Office Action Summary	Application No. 10/510,351	Applicant(s) BODNAR, ERNEST R.	
	Examiner CHRISTINE T. CAJILIG	Art Unit 3633

Title : STEEL STUD WITH OPENINGS AND EDGE FORMATIONS
AND METHOD

Bodnar '625

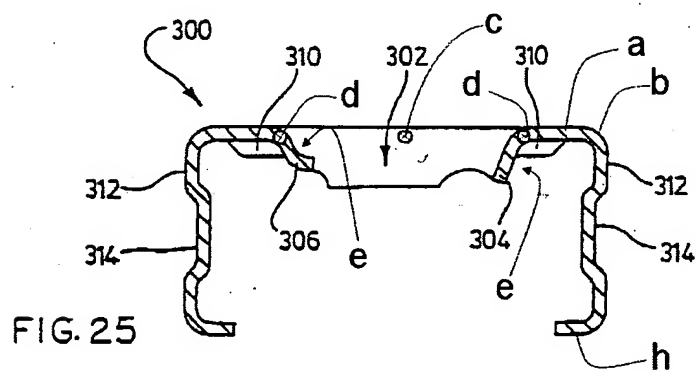
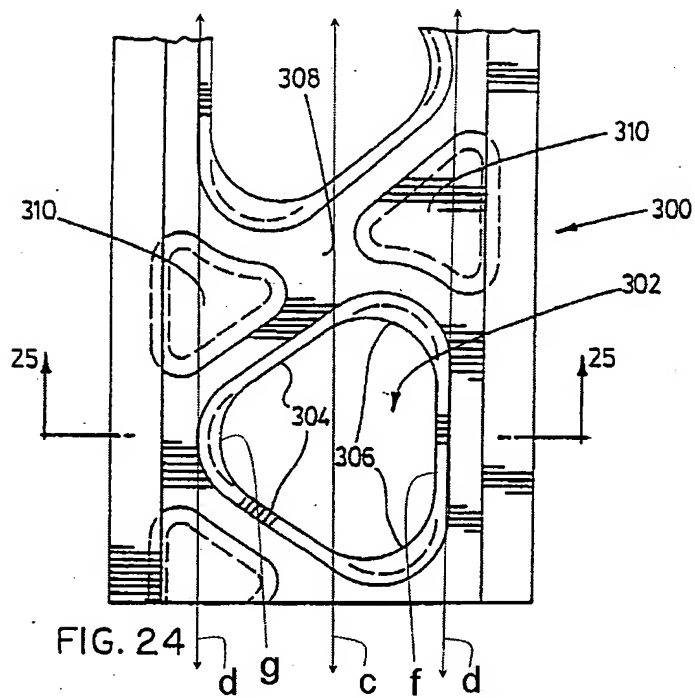
Regarding claim 1, Bodnar '625 in Figures 24-25 discloses a steel member for use in supporting structures and having reduced heat transfer characteristics as compared with solid web studs, and characterized by a web (a) defining side edges and an axis (c); a flange (312) on at least one side edge; openings (302) through said web at spaced intervals therealong, of predetermined size and profile, at least a side portion (304, 306) of said web being removed from said opening and remaining attached integrally to said web, and being bent away from said web along axes (d) parallel to said web axis (c).

Regarding claim 3, Bodnar '625 discloses the structure discussed above and further discloses that said side portion (304, 306) defines a channel shape (e) extending along an axis parallel to said web axis.

Regarding claim 4, Bodnar '625 discloses the structure discussed above and further discloses that said openings (302) are of a shape defining a linear side edge (f), and an arcuate side edge (g), said side portion (304, 306) of said web being integral with said linear side edge (f).

Regarding claim 5, Bodnar '625 discloses the structure discussed above and further discloses that there are two said flanges (312) one on each side of said web, being formed at normal to said web, and lips (h) formed along said flanges and normal to said flanges.

Regarding claim 6, Bodnar '625 discloses the structure discussed above and further discloses that openings (302) are arranged in an alternating orientation and struts (308) are defined between said openings, said struts extending diagonally across said member.

Regarding claim 26, Bodnar '625 in Figures 24-25 discloses a steel member having a web (a), side edges, and a flange (312) along at least one said side edge and openings (302) through said web wherein said openings (302) are formed in said web at spaced intervals therealong, with one of said openings leaving a side portion of metal attached to said web forming an edge flange (304, 306) along said at least one side edge of said web and forming said side portion out of the plane of said web wherein said side portion is bent along bend lines (d) parallel to the web axis (c). Therefore, the method steps set forth in claim 26 of forming the steel member with the above said structure and bending side portions would have been an obvious if not inherent method of making the steel member having the same structure.

Meyer '217

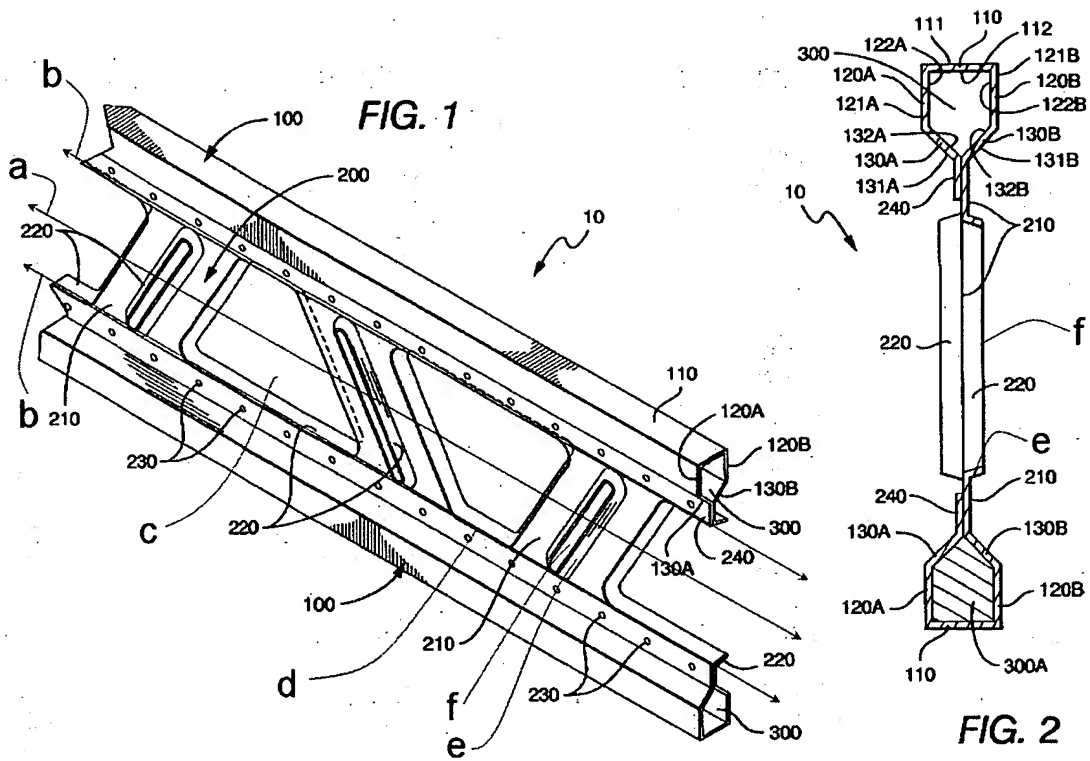
Regarding claim 1, Meyer '217 in Figures 1 and 2 discloses a steel member for use in supporting structures and having reduced heat transfer characteristics as compared with solid web studs, and characterized by a web (210) defining side edges and an axis (a); a flange (120a, 110) on at least one side edge; openings (c) through said web at spaced intervals therealong, of predetermined size and profile, at least a side portion (d, 220) of said web being removed from said opening and remaining attached integrally to said web, and being bent away from said web along axes (b) parallel to said web axis (a).

Regarding claim 2, Meyer '217 discloses the structure discussed above and further discloses depressions (e) formed in said web at spaced intervals, and an opening (f) formed in said depressions to reduce heat transfer.

Folsom '781

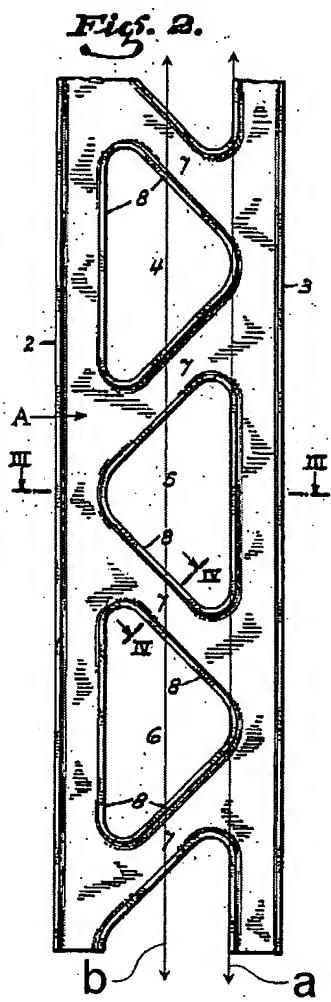
compared with solid web studs, and characterized by a web (A) defining side edges and an axis (b); a flange (3) on at least one side edge; openings (4-6) through said web at spaced intervals therealong, of predetermined size and profile, at least a side portion (8) of said web being removed from said opening and remaining attached integrally to said web, and being bent away from said web along axes (a) parallel to said web axis (b), but does not disclose that the member is steel. However, it would have been obvious to one having ordinary skill in the art at the time of invention to use steel, since it has been held to be within the general skill of a worker in the art to select a known material on the basis of its suitability for the intended use as a matter of obvious design choice. *In re Leshin*, 227 F.2d 197, 125 USPQ 416 (CCPA 1960)

Regarding claim 6, Folsom '781 discloses the structure discussed above and further discloses that said openings (406) are arranged in an alternating orientation and struts (7) are defined between said openings, said struts extending diagonally across said member.

Regarding claim 26, Folsom '781 discloses a steel member having a web (A), side edges, and a flange (3) along at least one said side edge and openings (4-6) through said web wherein said openings (4-6) are formed in said web at spaced intervals therealong, with one of said openings leaving a side portion of metal attached to said web forming an edge flange (8) along said at least one side edge of said web and forming said side portion out of the plane of said web wherein said side portion is bent along bend lines (a) parallel to the web axis (b). Therefore, the method steps set forth in claim 26 of forming the steel member with the above said structure and bending

Rafter '384

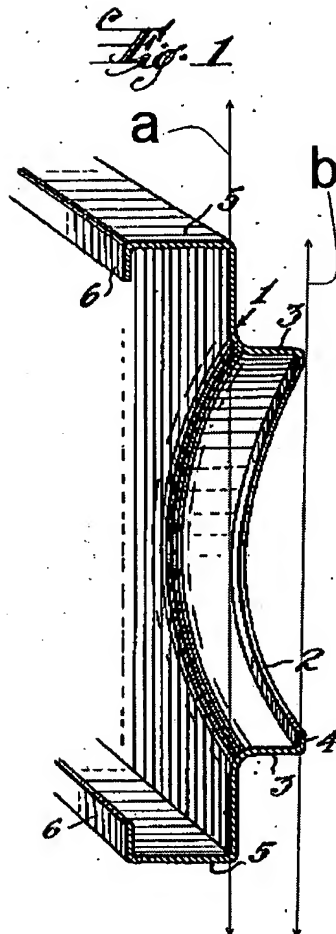
Regarding claim 1, Rafter '384 in Figure 1 discloses a metal member for use in supporting structures and having reduced heat transfer characteristics as compared with solid web studs, and characterized by a web (1) defining side edges and an axis (a); a flange (5) on at least one side edge; openings (2) through said web at spaced intervals therealong, of predetermined size and profile, at least a side portion (3, 4) of said web being removed from said opening and remaining attached integrally to said web, and being bent away from said web along axes (b) parallel to said web axis (a), but does not disclose that the member is steel. However, it would have been obvious to one having ordinary skill in the art at the time of invention to use steel, since it has been held to be within the general skill of a worker in the art to select a known material on the basis of its suitability for the intended use as a matter of obvious design choice. *In re Leshin*, 227 F.2d 197, 125 USPQ 416 (CCPA 1960)

Regarding claim 3, Rafter '384 discloses the structure discussed above and further discloses that said side portion (3, 4) defines a channel shape (created by 3 and 4) extending along an axis (between axes a and b) parallel to said web axis.
